# Access Compliance Report

## Public Rights-of-Way

Intersection ID: 4129	Main Street: ANDREW_JAMES_DR	Cross Street: RENEE_SAVANNAH_LN	Location: NW
ADA ID: 1AAB96D5D7B4	Ramp Type: Perp	Initial Pass/Fail: Fail	Overall Compliance: No
		Severity Score: 25

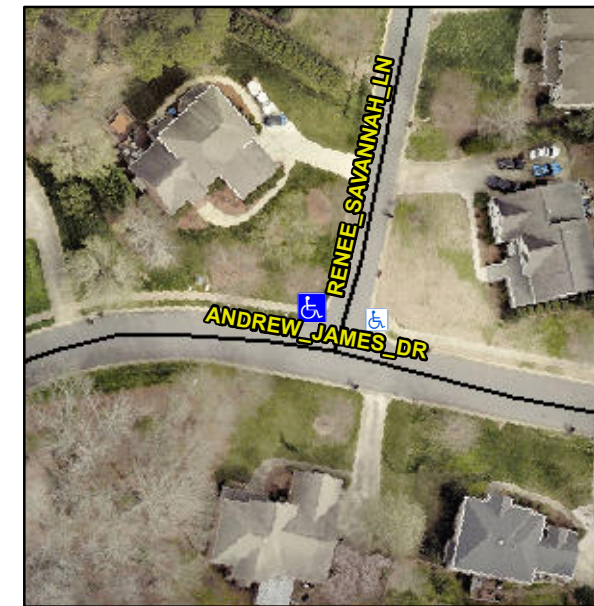
Possible Solutions:

**Remove & Replace Entire Ramp.**

PROW/ADA:

**R304.5.3**

Compliance	Description	Data	Compliance	Description	Data
N/A	Ramp Length (in)	96.0	Yes	Ramp Slope (%)	5.2
Yes	Ramp Width (in)	52.5	No	Ramp XSlope (%)	8.8
N/A	Flare Type LT	N/A	N/A	Flare Type RT	N/A
N/A	Flare Slope LT (%)	N/A	N/A	Flare Slope RT (%)	N/A
N/A	Flare Traversable LT?	N/A	N/A	Flare Traversable RT?	N/A
N/A	Landing Length (in)	N/A	N/A	DWS Provided?	N/A
N/A	Landing Width (in)	N/A	N/A	DWS Contrast?	N/A
N/A	Landing Slope (%)	N/A	N/A	DWS Length (in)	N/A
N/A	Landing X Slope (%)	N/A	N/A	DWS Full Width?	N/A
N/A	Landing Curb? (Y/N)	N/A	N/A	DWS Offset (in)	N/A
N/A	Shared Landing?	N/A			
N/A	Gutter Ponding?	N/A	N/A	Gutter Slope (%)	N/A
N/A	Gutter Lip Ht (in)	N/A	N/A	Gutter X Slope (%)	N/A
N/A	Painted X Walk1?	No	N/A	Painted X Walk2?	N/A
	X Walk 1 Direction	To SE		X Walk 2 Direction	N/A
N/A	X Walk 1 Width (in)	N/A	N/A	X Walk 2 Width (in)	N/A
	X Walk 1 Slope (%)	3.0		X Walk 2 Slope (%)	N/A
	X Walk 1 X Slope (%)	3.8		X Walk 2 X Slope (%)	N/A
